HISTORIC AND DESIGN REVIEW COMMISSION

March 20, 2019

HDRC CASE NO:	2019-110
ADDRESS:	1201 E CROCKETT ST
LEGAL DESCRIPTION:	NCB 1373 BLK 1 LOT W 77.4 FT OF 9 & 10
ZONING:	MF-33, H
CITY COUNCIL DIST.:	2
DISTRICT:	Dignowity Hill Historic District
APPLICANT:	Nate Manfred
OWNER:	Keith Jones
TYPE OF WORK:	Addition of a dormer on rear roof slope
APPLICATION RECEIVED:	March 01, 2019
60-DAY REVIEW:	April 30, 2019
CASE MANAGER:	Huy Pham

The applicant is requesting a Certificate of Appropriateness for approval to install a dormer on the eastside roof, perpendicular to the E Crockett façade.

1201 EAST CROCKETT HOUSE SECTION THRU DORMER

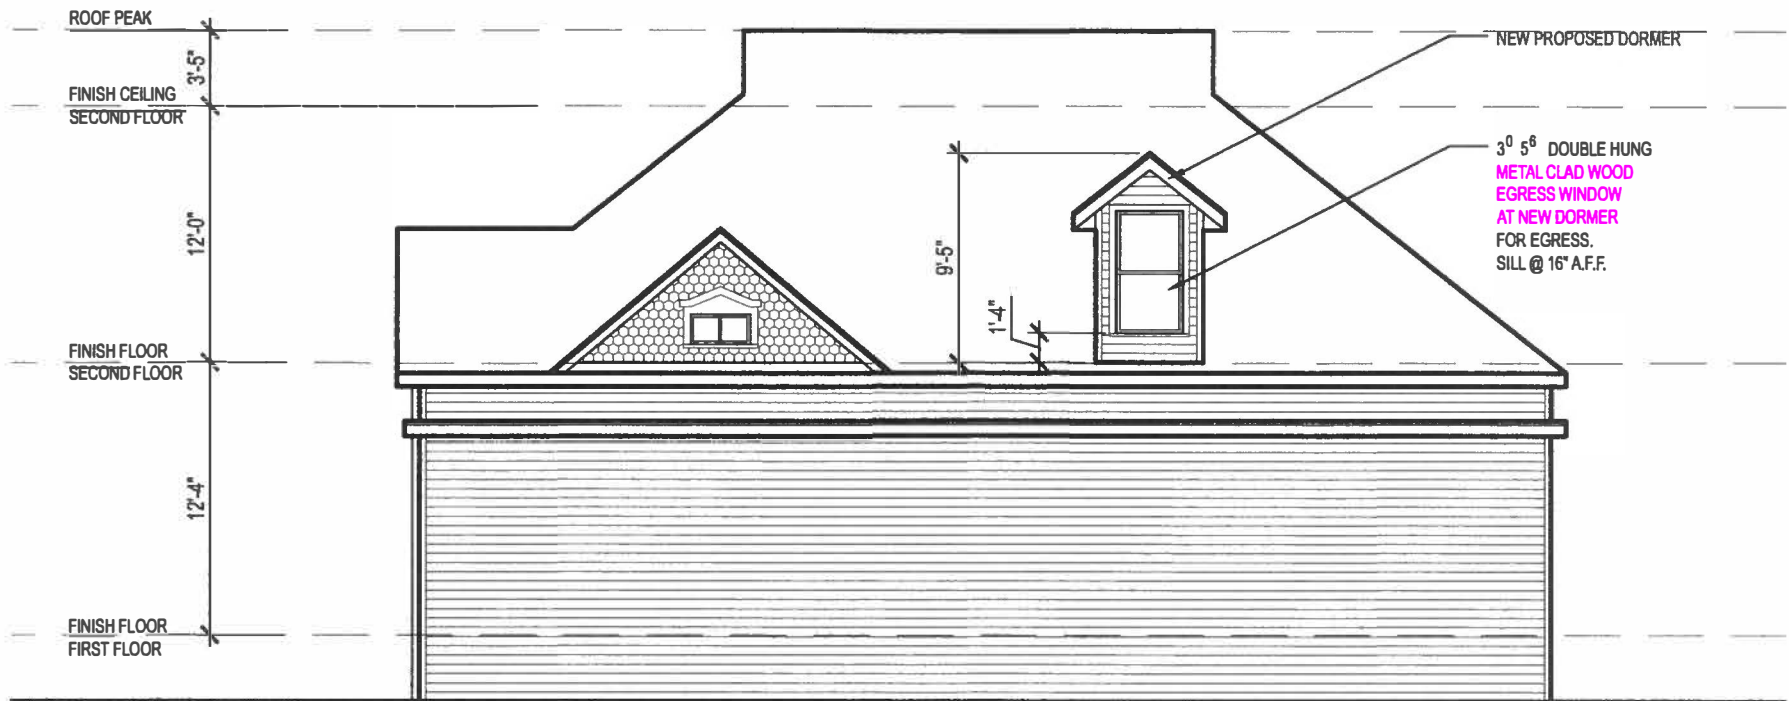
- a. The primary historic structure at 1201 E Crockett was constructed circa 1900 in the Queen Ann style and first appears on the 1904 Sanborn map. The one-story, single-family structure originally featured two wraparound porches with turned columns and spindle details.
- b. **DORMER** – The applicant has proposed to install a dormer on the eastside roof, perpendicular to the E Crockett

façade. This request was proposed in pursuit of compliance of the fire code that requires egress for an attic bedroom. Per the Guidelines for Additions 3.1.B.iii notes that dormers should be compatible in size, scale, proportion, placement, and detail with the style of the house. Additionally, the Guidelines note to locate dormers only on non-primary facades (those not facing the public right-of-way) if not historically found within the district. Staff finds that the proposed dormer is consistent with the Guidelines.

Staff recommends approval of the new dormer based on finding b.
